Rework Second Generation Box Sensor for use with Ioline 68331 PCB Assemblies

3.27.2008
KSR

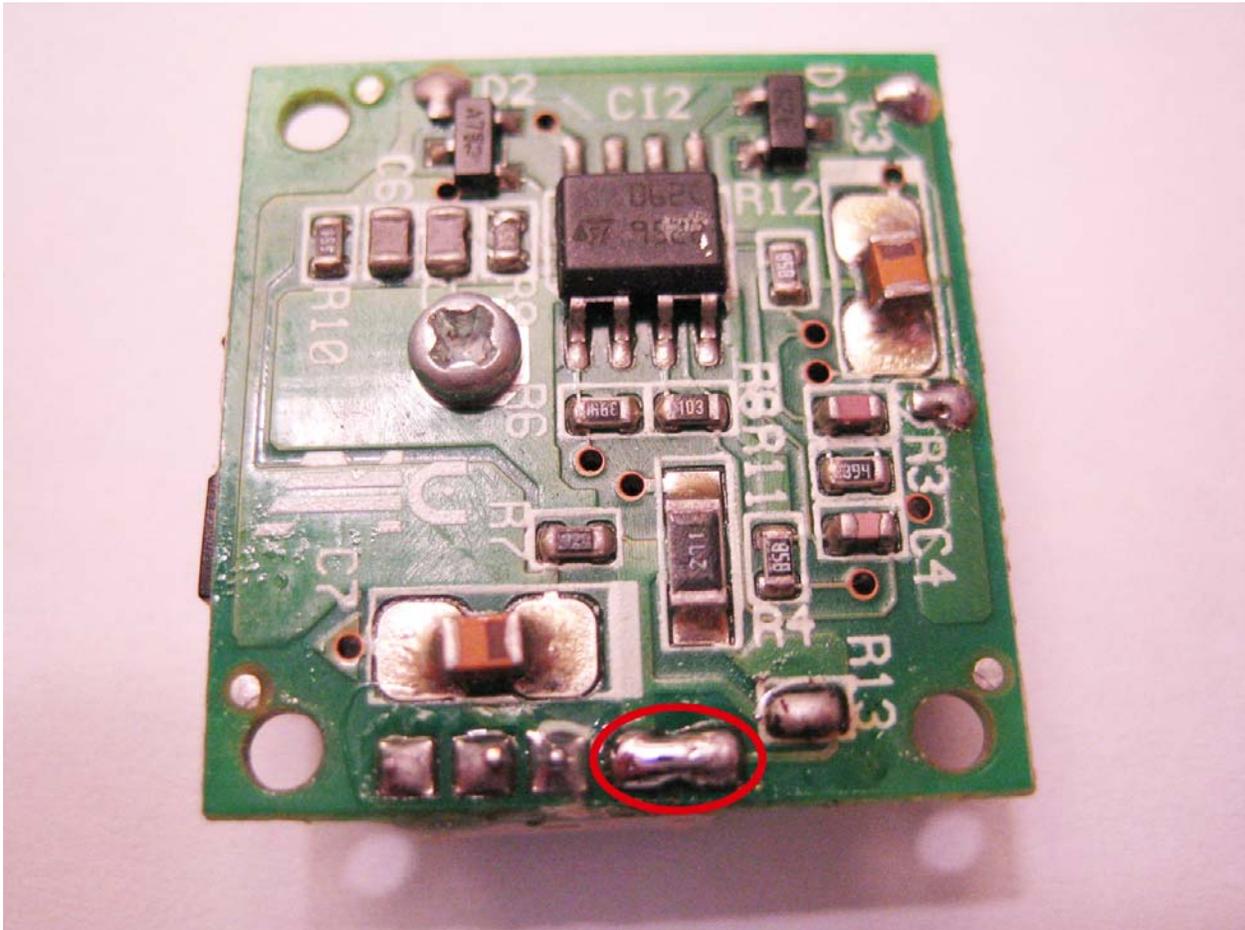
1. Remove the sensor from the assembly it is attached to (if required).
2. Find the Pin 1 and Pin 2 solder points on the back of the 5 pin connector as indicated in the image below.

3. Solder Pins 1 and 2 together to make the sensor work with the power circuit on the 68331 PCB (see below).
